STATE OF ALASKA
DEPARTMENT OF TRANSPORTATION AND PUBLIC FACILITIES

EDNA BAY ALASKA

PROJECT LAYOUT

As built 8-85

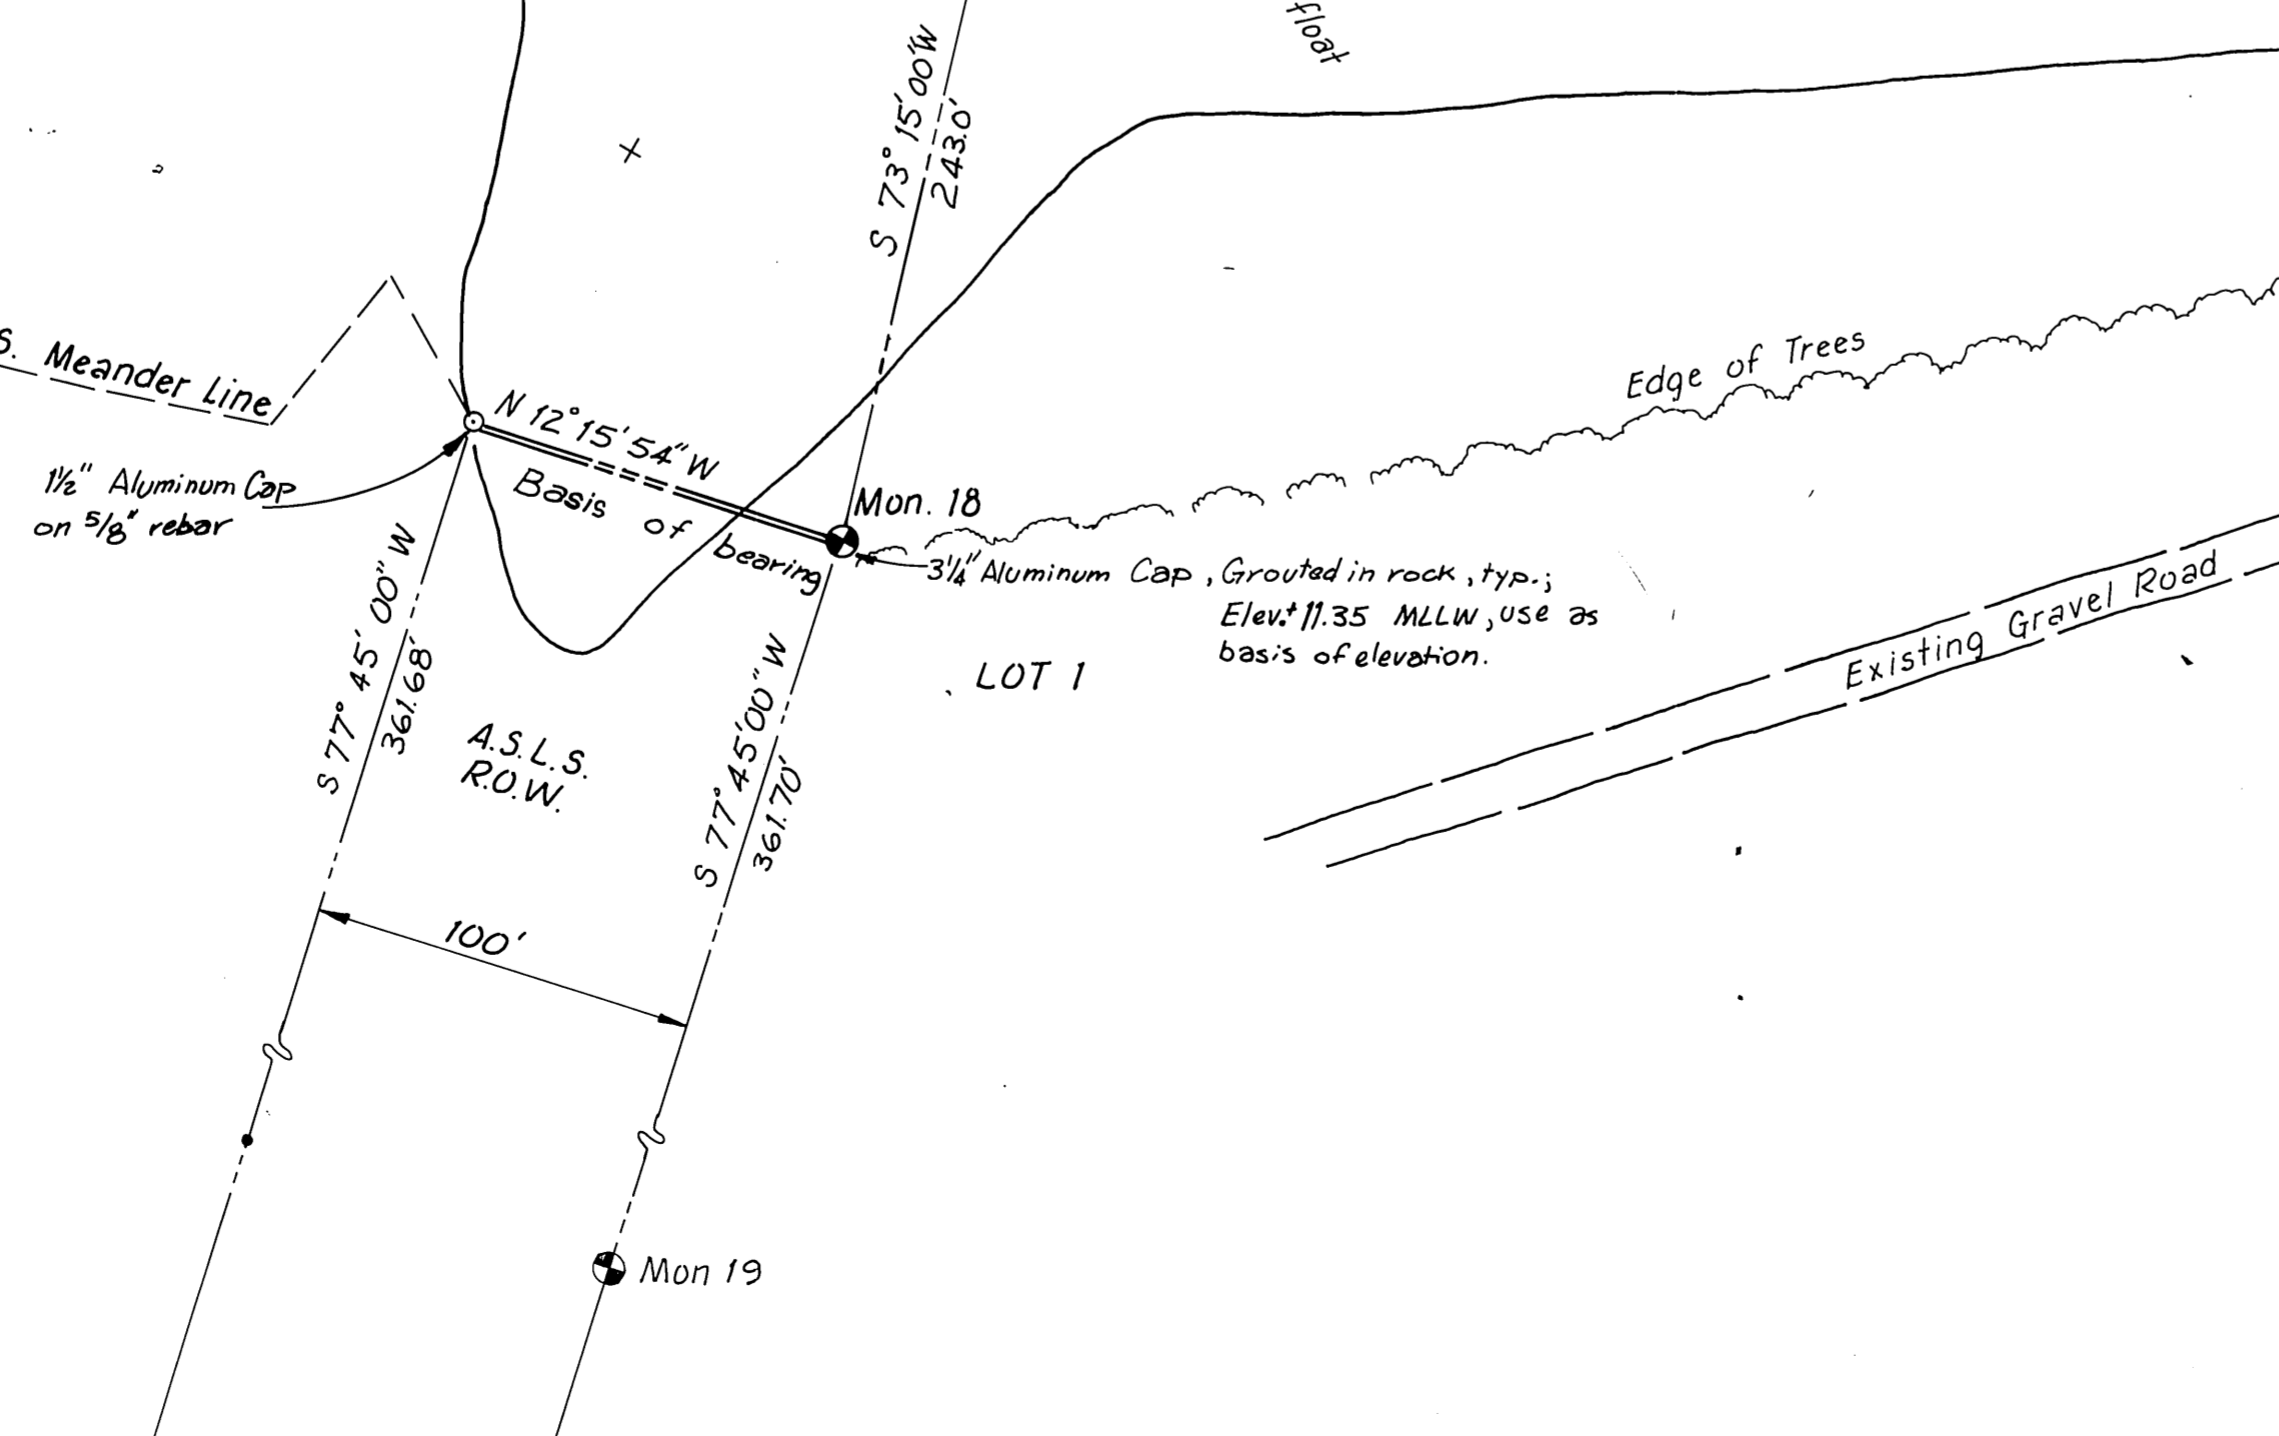
Float was moved out 6' at design's request to allow add'l. room inside for stall floats - wanted 10' but water depth wouldn't allow it - water actually deeper than shown - See pile records.

PLAN
1/2" = 1'-0"

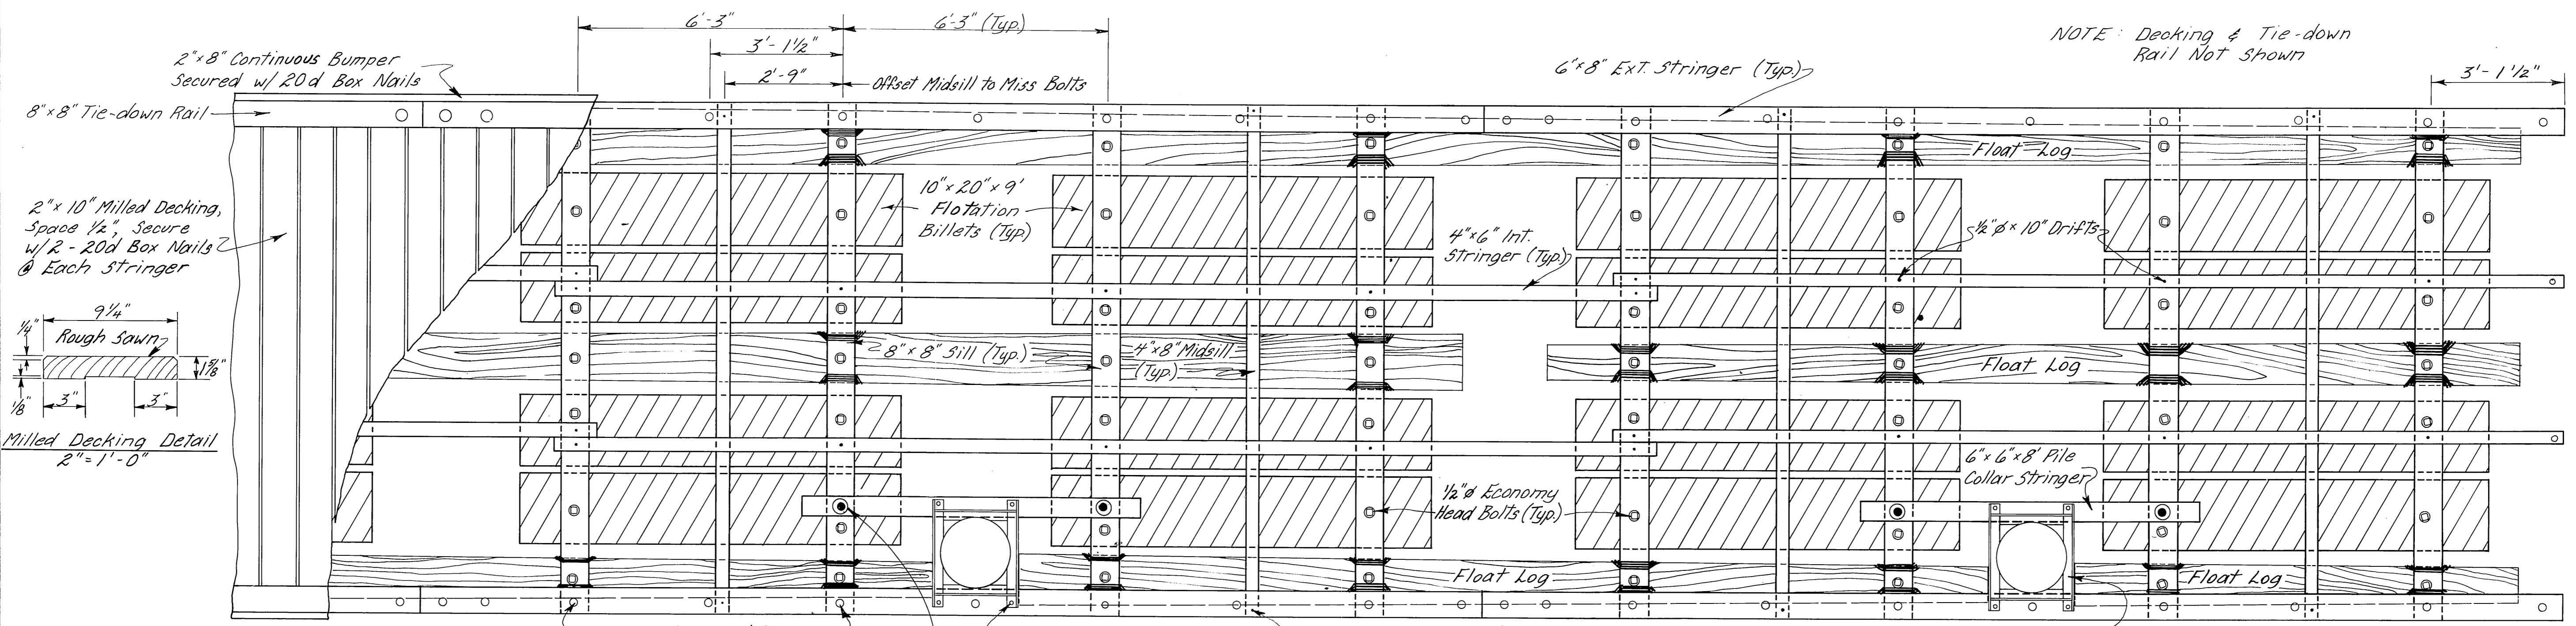
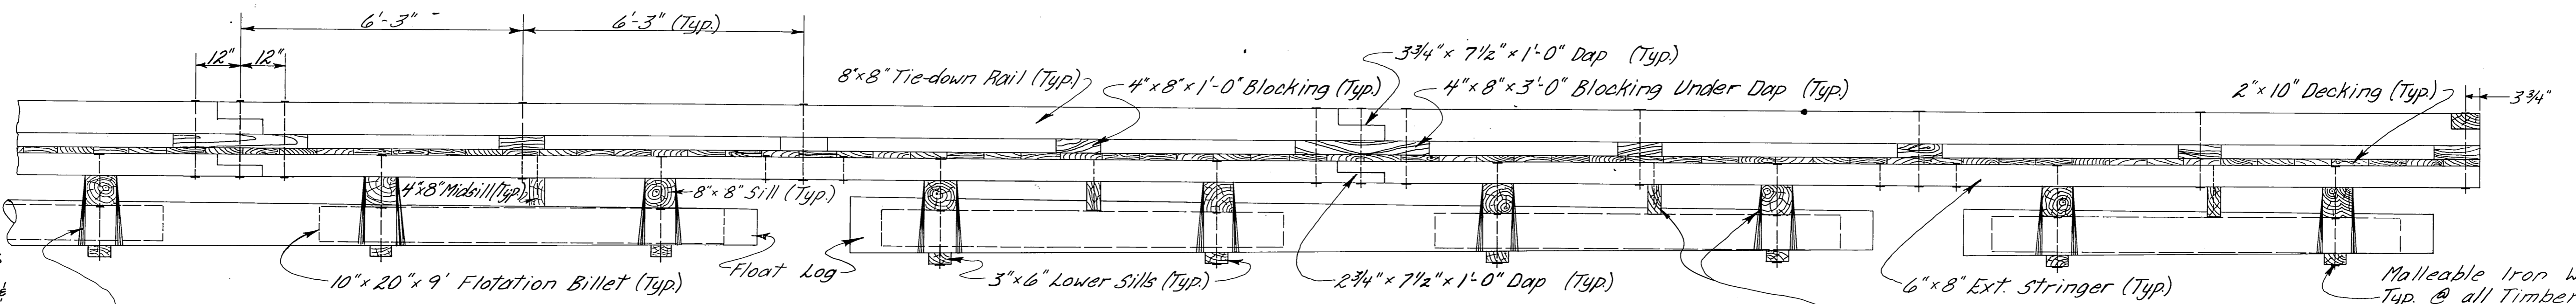
3 wraps of 4 crosslashed to allow stapling into pile near top- flotation billets interfere with hammer swings lower down.
